PREVIOUS CUI DEVICES DETAIL / IMAGE

NEW CUI DEVICES DETAIL / IMAGE

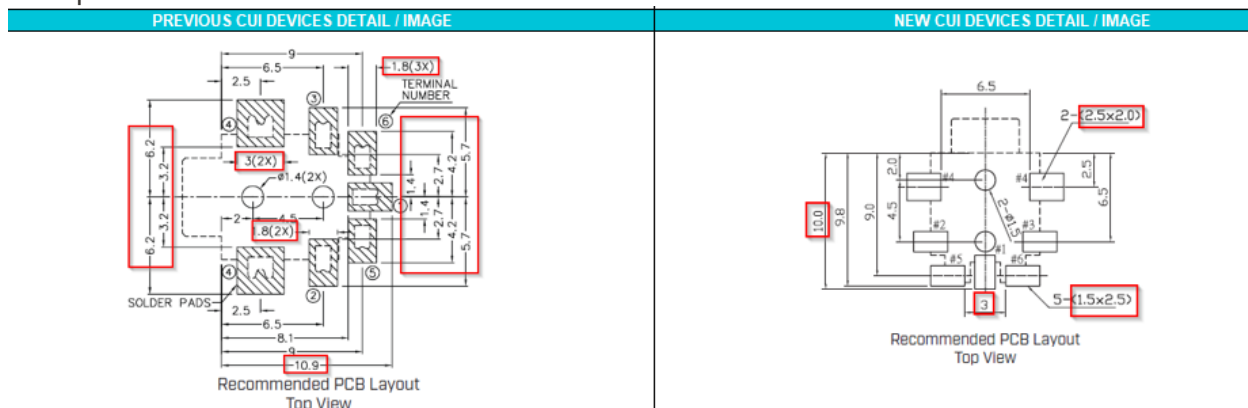
2. PCB pad size differs
